12500 Ardennes Avenue, Sketch Plan No. 320180200

Completed: 7/08/2019

Proposed residential project with up to 198,718 square feet of residential uses, with associated public benefits to support incentive density.

Figure 3 Sketch Plan

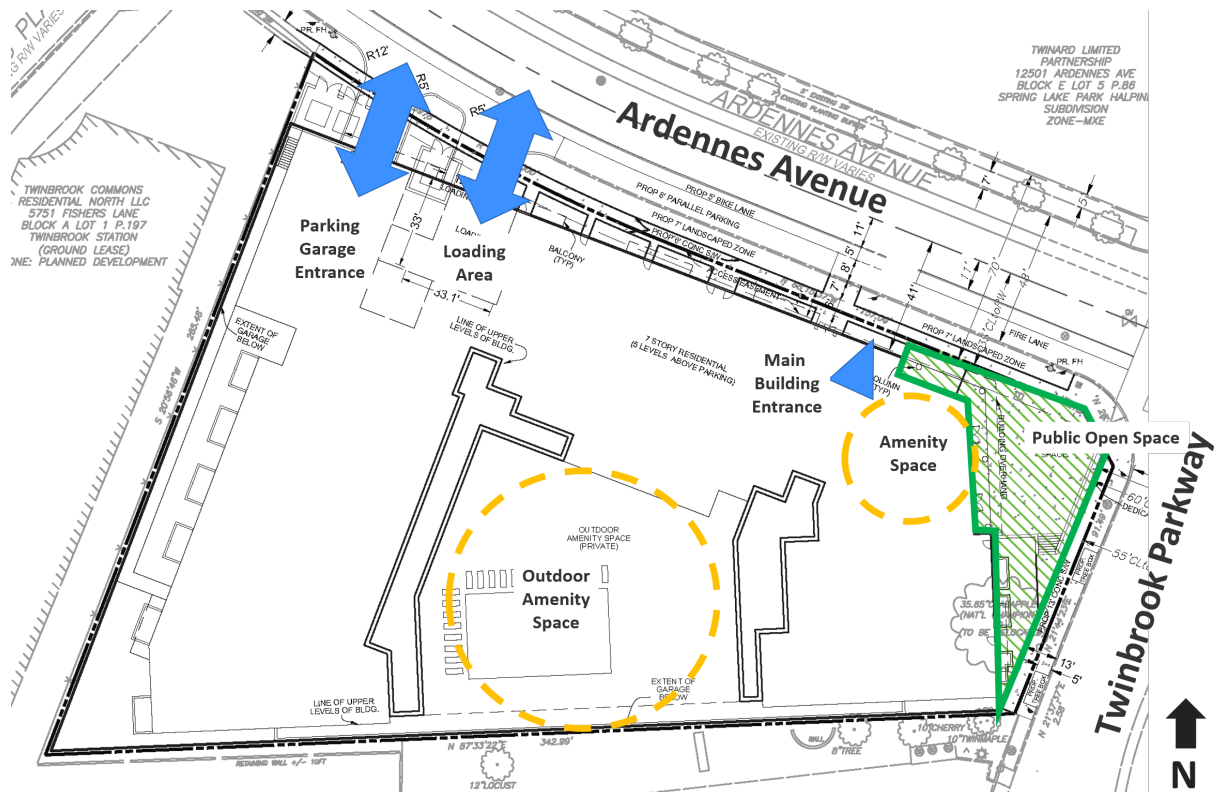
During the future stages of regulatory review, Staff will work with the applicant to ensure the following:

- The design of the public open space is usable and welcoming.
- Transformers and utilities are located away from public view.
- Adequate buffer is designed between the development and existing buildings to the west and south.

- The ground floor of the building has residential units and amenities that open on to the street.
- The streetscape creates a comfortable walking environment along Twinbrook Parkway and Ardennes Avenue.

- The architecture expresses a dynamic building form that responds to the context and adds to the character of the neighborhood. The following strategies may be explored:

- A more dynamic roof line with, accentuating key corners and important vistas.
 - Locating certain amenities on the roof and making it accessible to residents.

- A more refined corner element at the intersection of Twinbrook Parkway and Ardennes Avenue.
 - Further emphasizing the entrance to the building along Ardennes Avenue.

- Including balconies facing the street into the design of the elevations.
 - Providing human scale elements along the ground floor along both streets.

- Designing the amenities along Twinbrook Parkway in a way that integrates the amenities and the Public Open Space seamlessly.
 - Providing amenities on the ground floor that are open to the public.

- Making the end facades facing Twinbrook Parkway and Ardennes Avenue more attractive through massing variation, additional fenestrations, public art etc.

- Appropriately screening exposed parking garage facades.

PUBLIC OPEN
SPACE

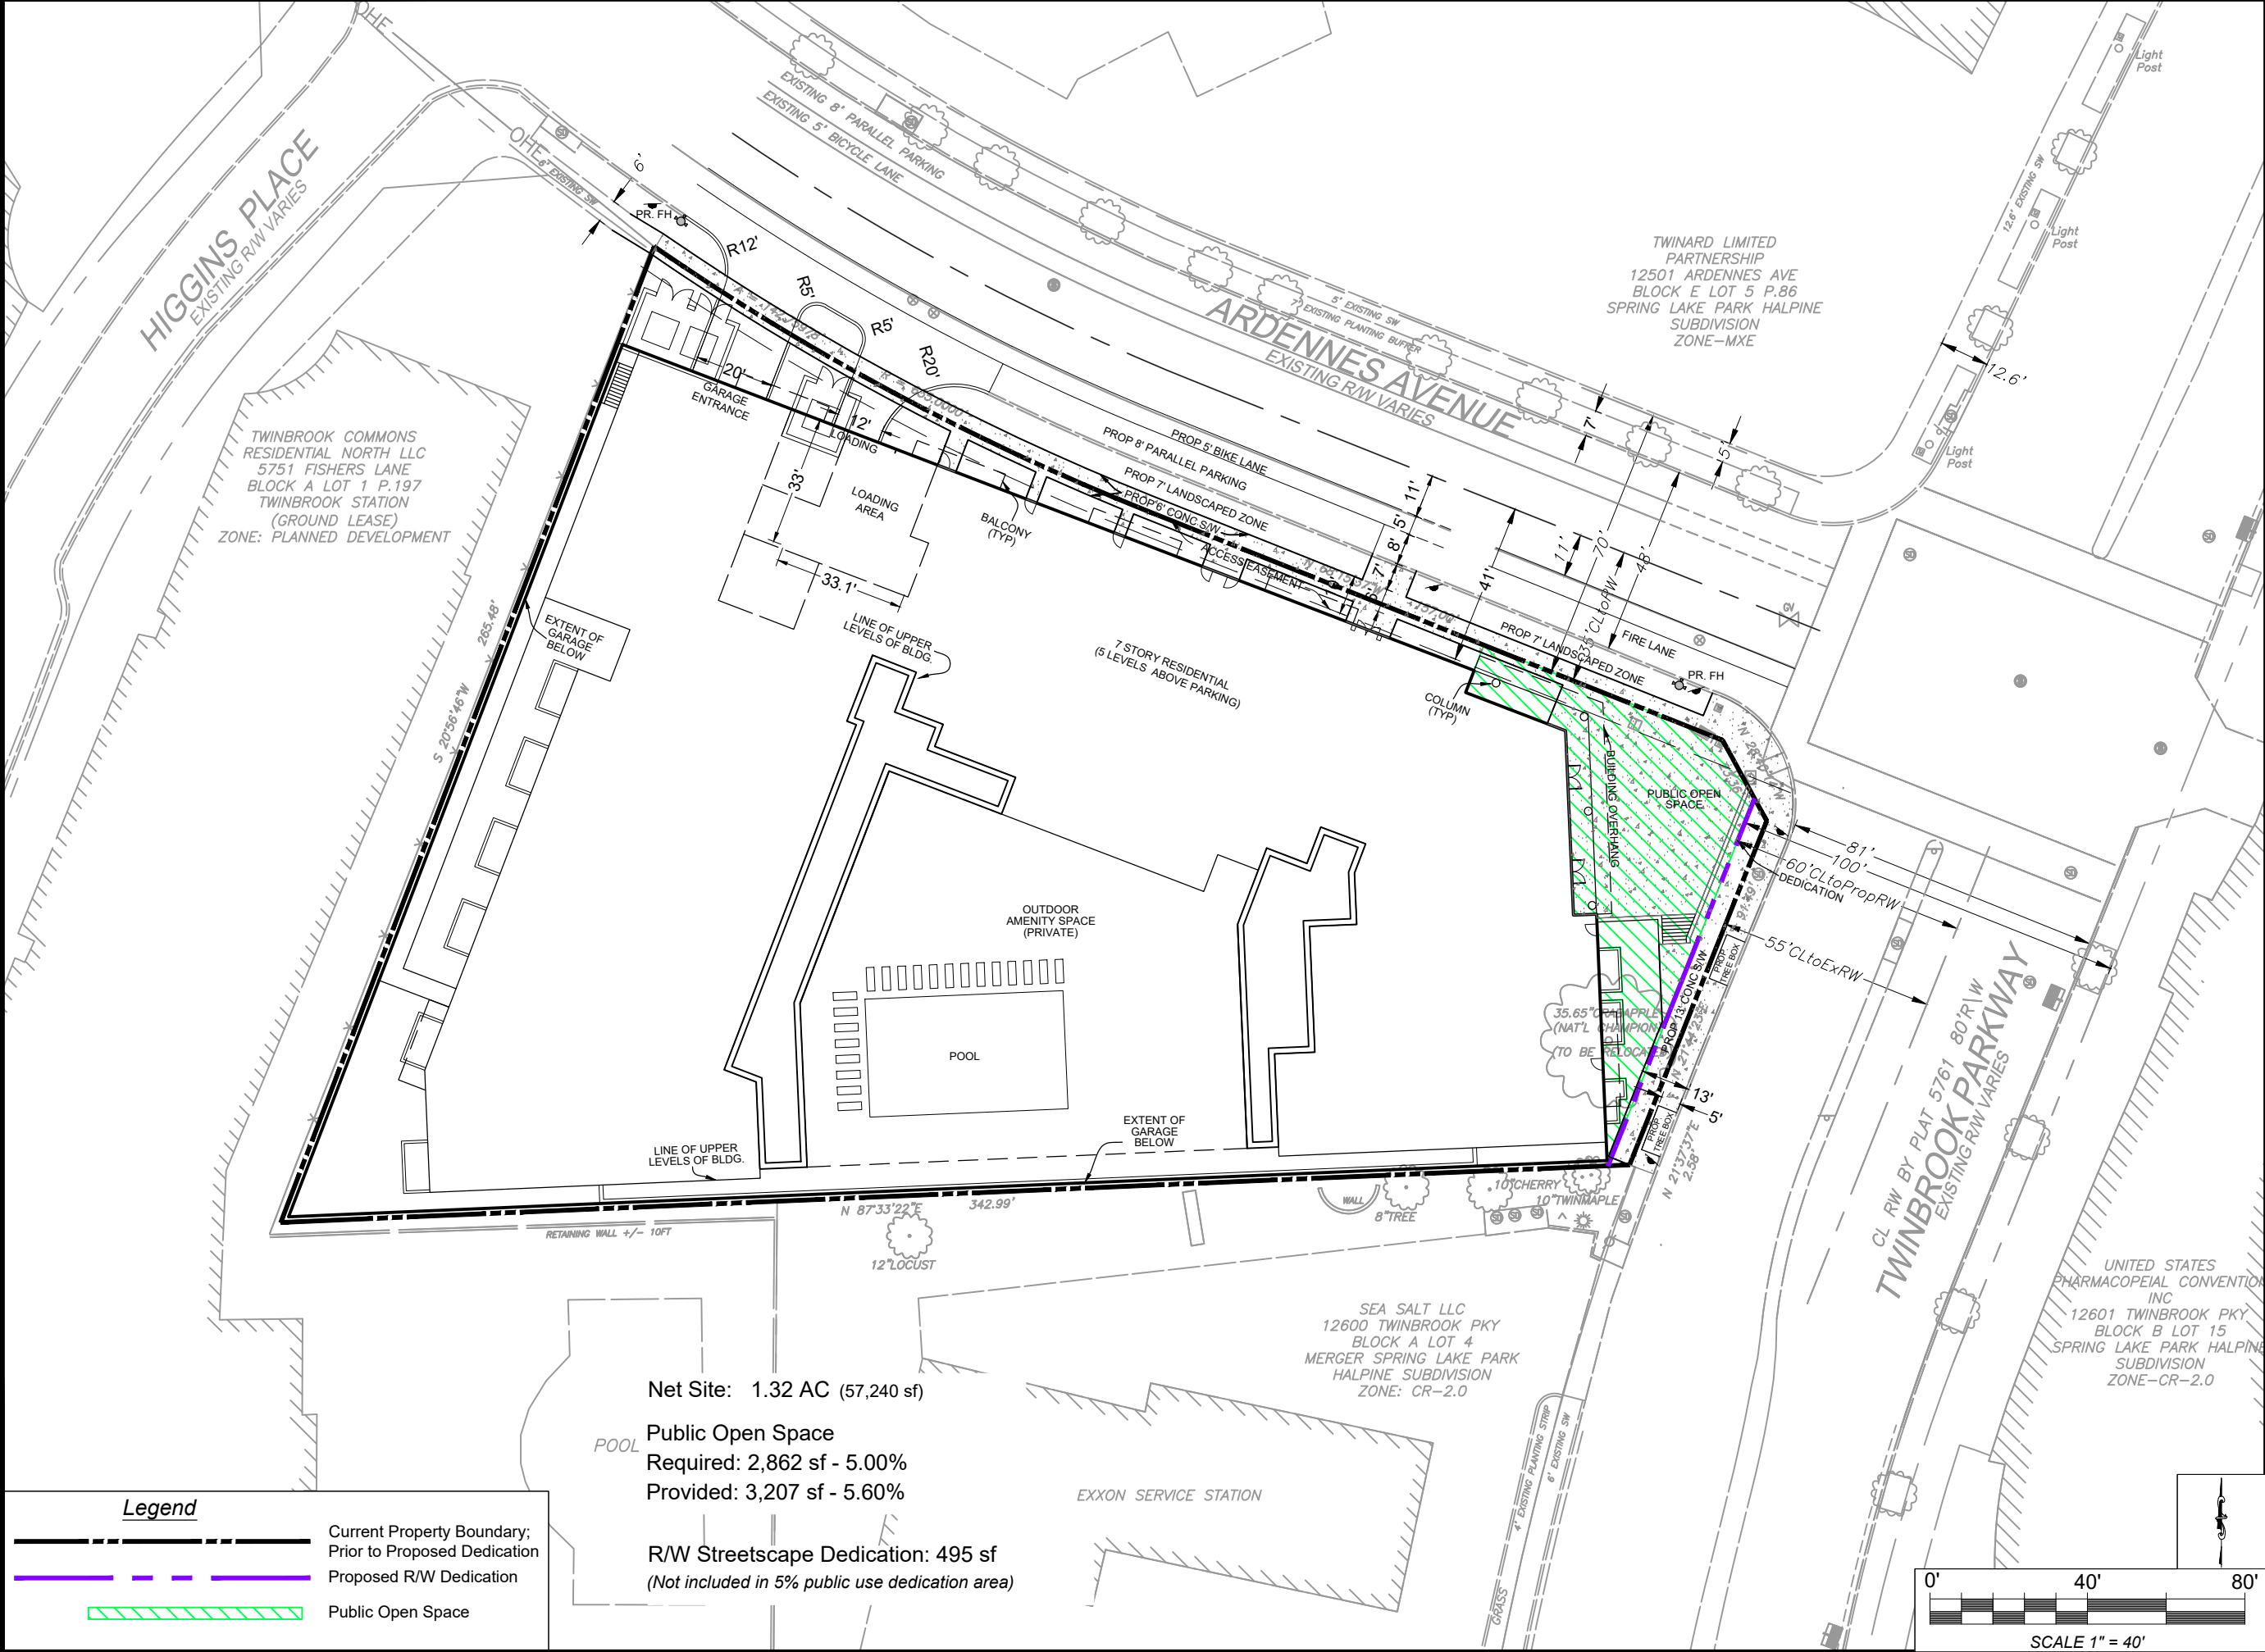
The Applicant is required to provide 5% of the Site, or 2,862 square feet, as Public Open Space. The Applicant is proposing up to 3,207 square feet of open space at this time. The public open space is located at the northeast corner of the site, at the intersection of Ardennes Avenue and Twinbrook Parkway. The public open space will be designed using a mixture of hardspace and greenspace and will provide a welcoming transition from the busy intersection. While access from adjacent sidewalks is facilitated and encouraged, the site elements provide buffering from passing traffic while negotiating the necessary change in grade.

PEDESTRIAN/ VEHICLE
CIRCULATION, PARKING
AND LOADING

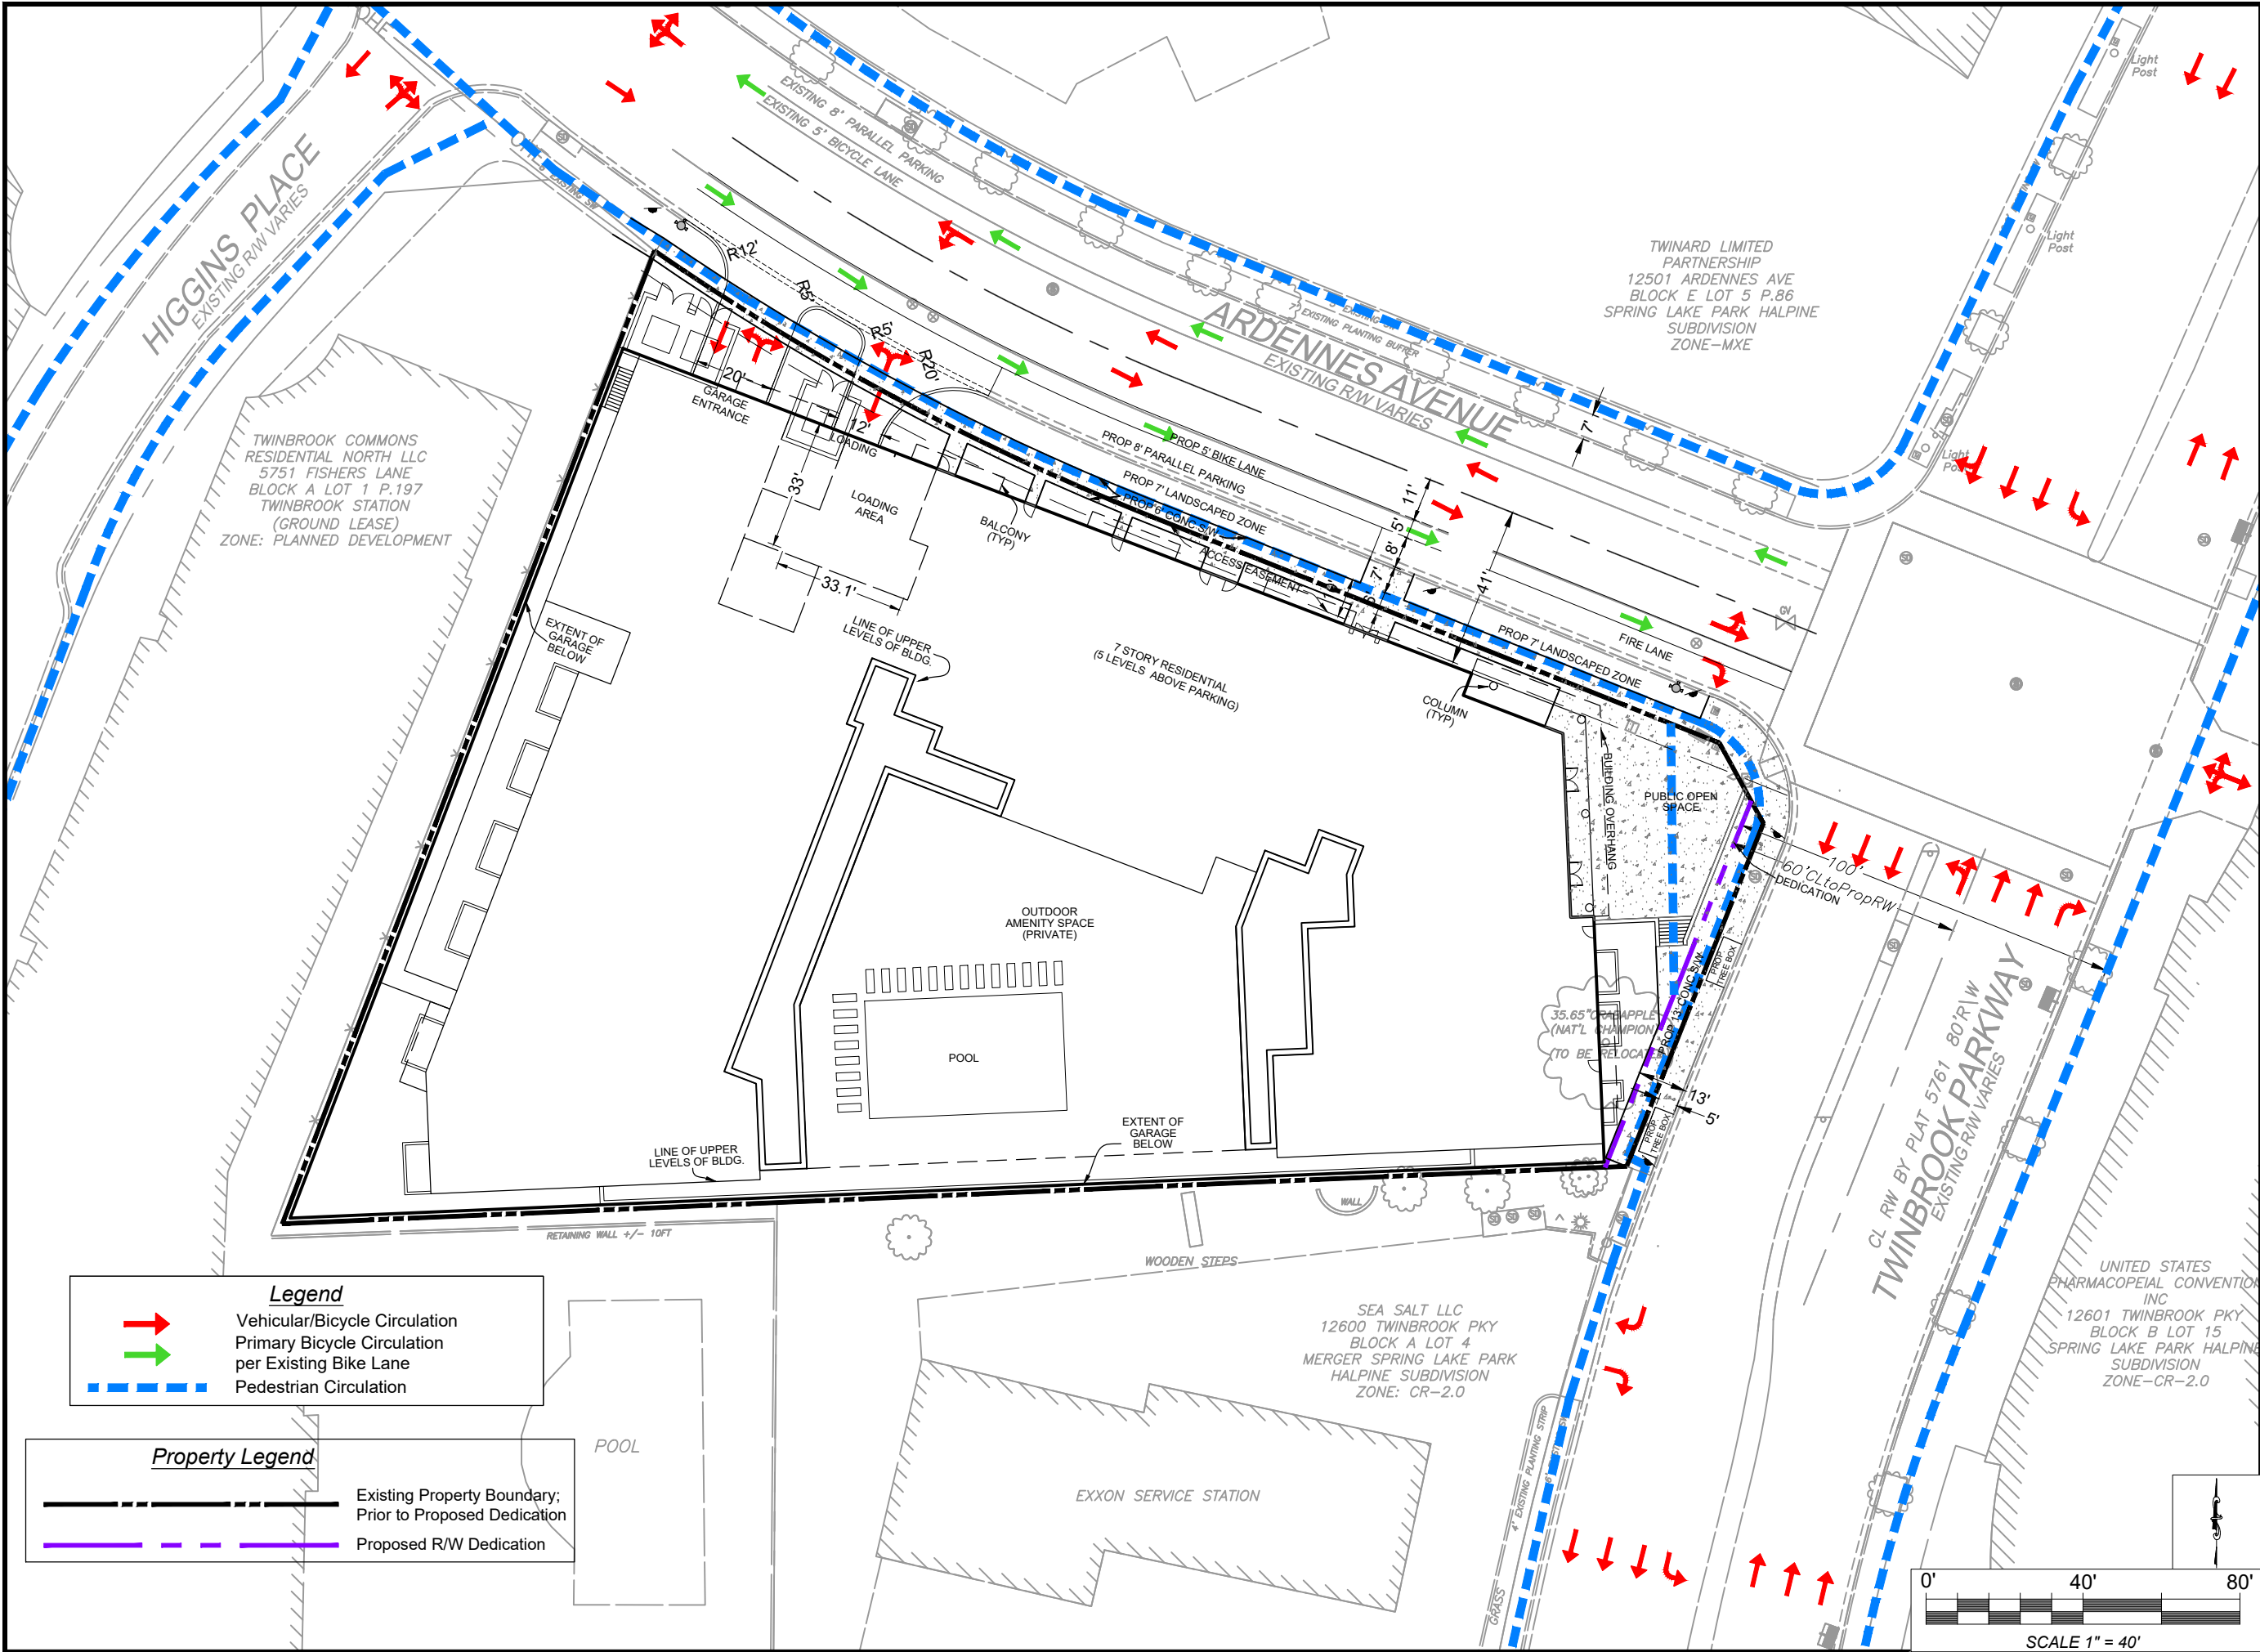
4. Twinbrook Parkway
 - a. Master Plan calls for 120-foot right-of-way. The existing right-of-way is 80 feet. The applicant proposes to dedicate an additional 5 feet. Plat #23312, which is the most recent plat, shows Twinbrook Parkway with an 80-foot right-of-way. DOT is concerned that this plan shows 100-feet. At preliminary plan, the applicant needs to provide additional information to determine how much dedication is required along Twinbrook Parkway to meet the Sector Plan.

- b. The Bicycle Master Plan calls for separated bike lanes. The applicant needs to show how this facility will fit on the road in plan view and provide a cross section.

5. At preliminary plan stage submit the following:
 - a. Provide a cross-section of Twinbrook Parkway with the proposed bicycle facilities.
 - b. Storm drainage and/or flood plain studies, with computations for any portion of the subject site that drains to the Montgomery County public storm drain system. Analyze the capacity of the existing public storm drain system and the impact of the additional runoff. If the proposed subdivision is adjacent to a closed section street, include spread computations in the impact analysis.
